RECALL 17V-047: DRIVER'S FRONT AIR BAG MODULE – PRIOR PARTS REPLACEMENT

This Service Information bulletin replaces SI B65 02 17 **dated April 2017**

RE: Recall 17V-047: Driver's Front Air Bag Module B65 02 17

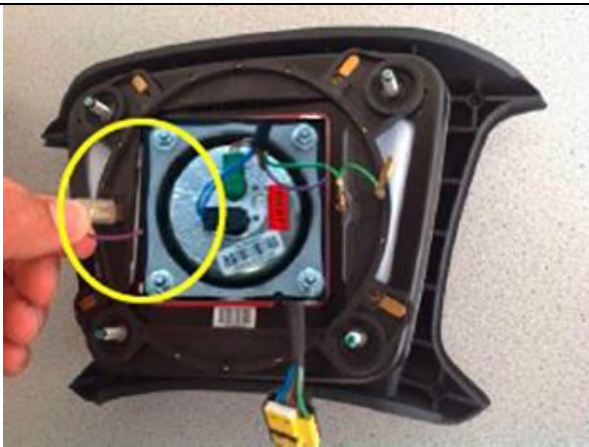
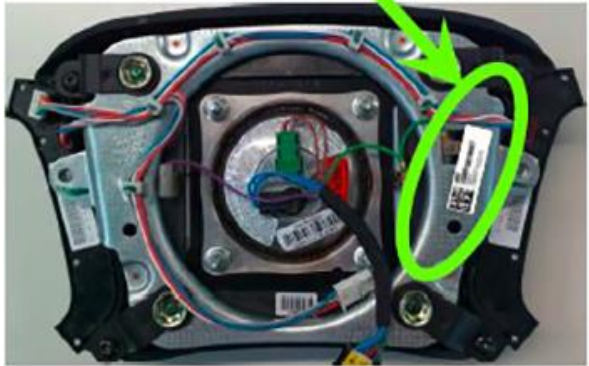
On vehicles with a basic steering wheel, the horn ring must be removed from the new part. To do so, proceed as follows:

<p>1. Remove horn ring.</p> <ul style="list-style-type: none">• Unplug the connector for the grounding cable (see the green arrow in the figure)• Remove the nuts (see the blue mark in the figure, Torx 55).
	<ul style="list-style-type: none">• Take off the horn ring, making sure that the springs remain in place.• Remove the horn contact plate.• Separate components after disassembly:<ul style="list-style-type: none">1 - Air bag module2 - Horn ring3 - Horn contact plate4 - Torx nuts

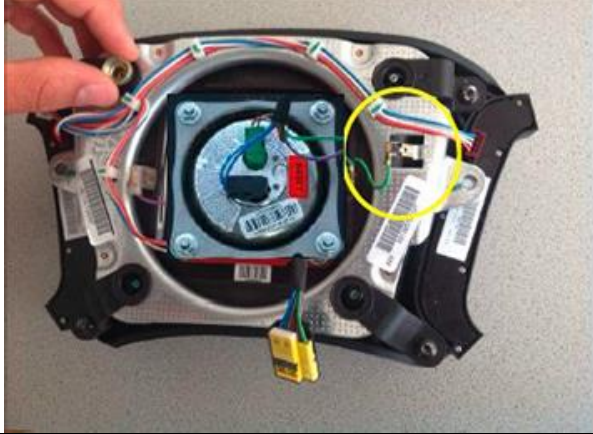
2. Prepare the new air bag module and pull off one of the two labels with the barcode and serial number of the air bag module. This must be stuck onto the horn ring **after** installation.
